ControlLogix Drive Module (v1.20)

(Cat. No. DMF30)

These release notes correspond to major revision 1, minor revision 2 of the SF3000 Interface (1756-DMF30) firmware. Use this firmware release with:

Publication 1756-RN685A-EN-P - September 2010

Alternator Power Selection, P2200 [PMI Drive Config], B14 "AltrnatorPwr"

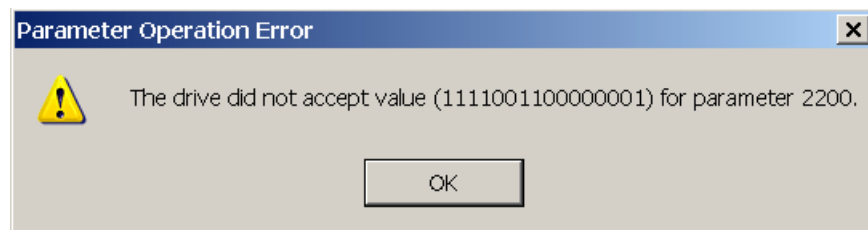
For cases where alternator power is used instead of utility power, this option has been added to allow the drive to better track the AC Line Frequency. The trade off is that the line frequency filtering is reduced when the Alternator Power option is selected.

The program defaults to selecting "Alternator Power," to provide the best frequency tracking, whether connected to the Utility power or Alternator power. It is recommended to have "Alternator Power" selected.

Note: The program will not allow the Alternator bit to be changed unless both the FML and the CML are not running. The error message shown below displays if an attempt is made to change the state of the Alternator Bit with the FML or the CML active.

Parameter 166 [Motor Cntrl Cmmd], Bit 21 Changed to “Reserved”

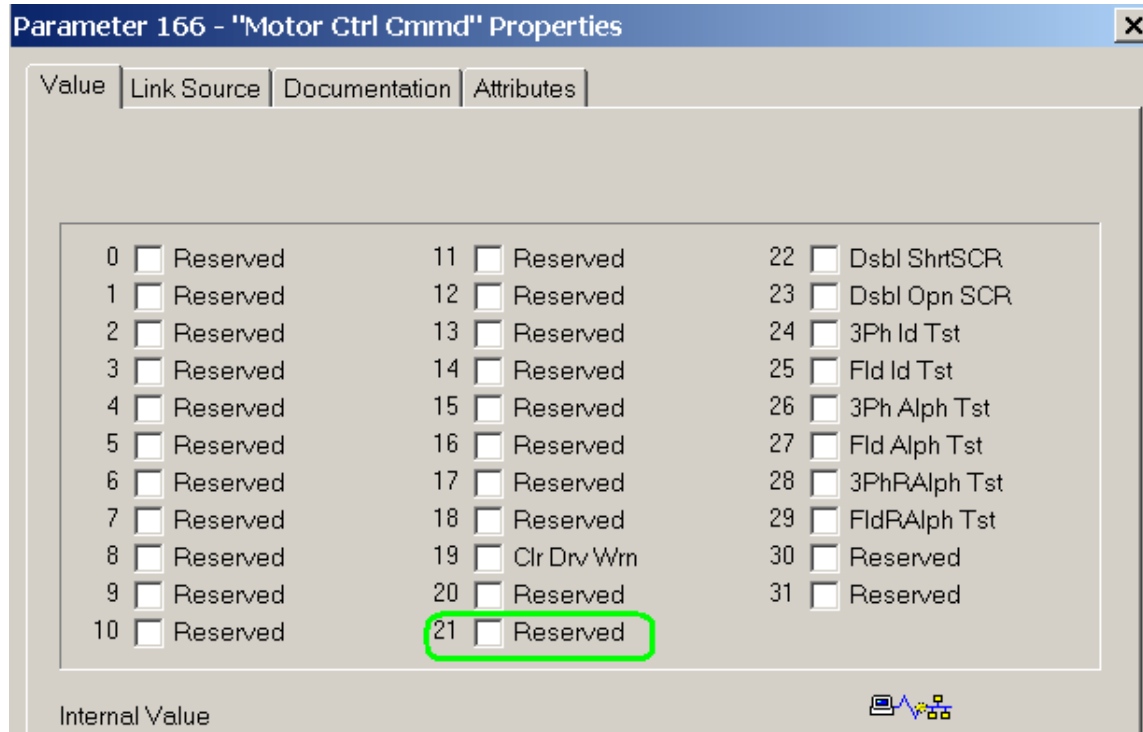
Parameter 166 [Motor Cntrl Cmmd], bit 21 “Dsbl Fld Wk” should have been defined as “Reserved”. Because CEMF regulator is not available in the DMF30 drive module, this bit has been changed to “Reserved”.

Figure 1 - Case 1, 3 Phase (Non-Regen), 2 Quad with Field

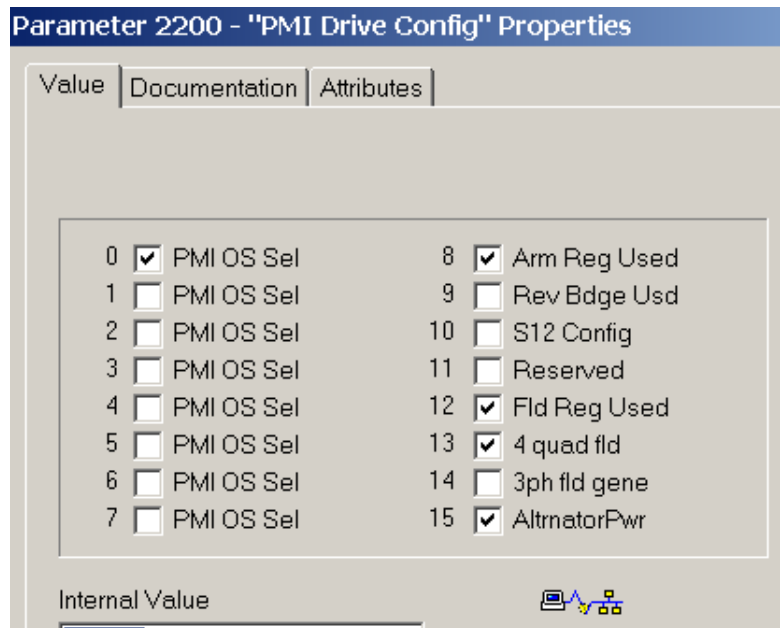
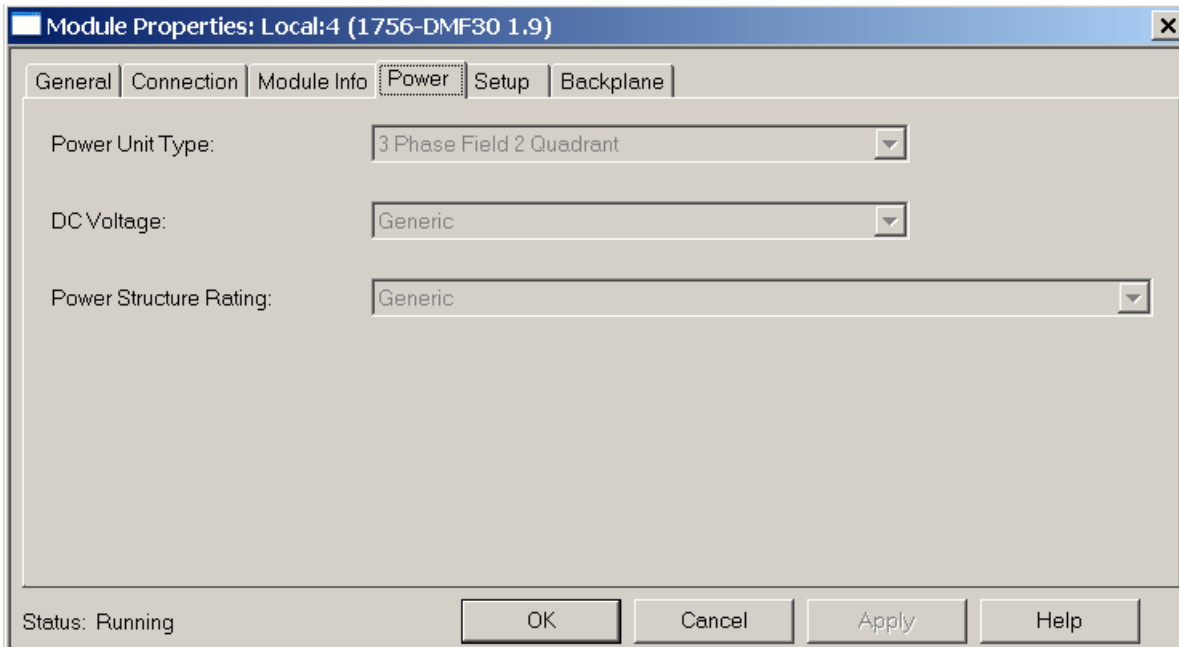
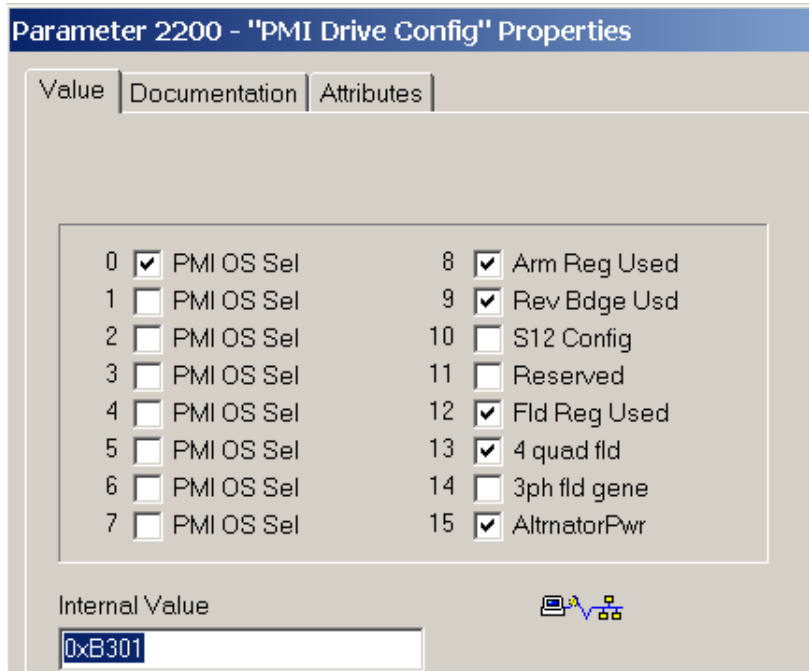
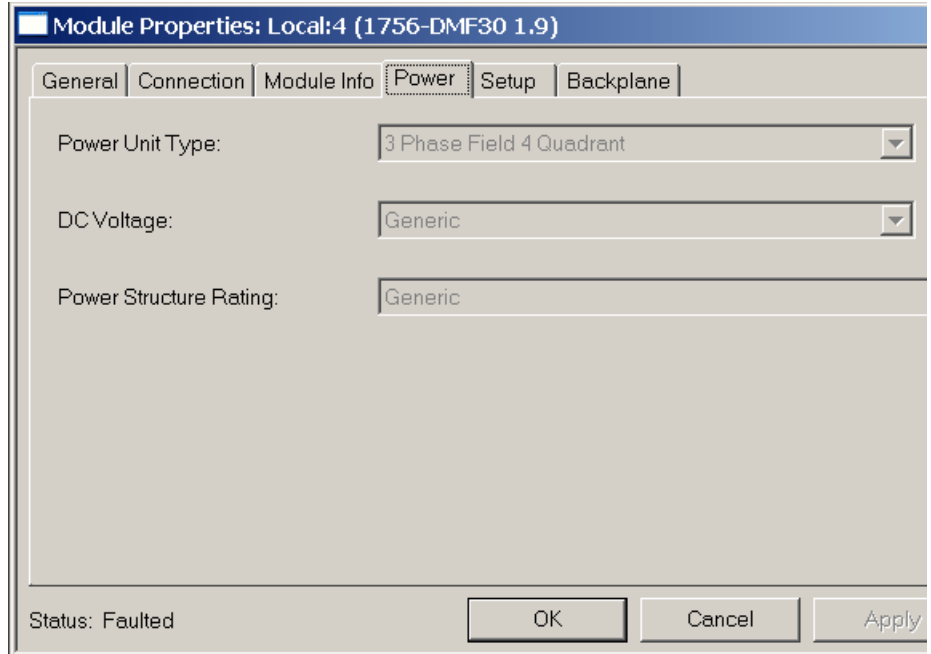
The power code selections were updated to reflect that there is only an S2R Field Power Module available as well the default parameters appropriate with the power code selected.

Note: Parameter 2214 reflects an earlier build of the software during the program updates. The number that appears in parameter 2214 for the final build is “18”.
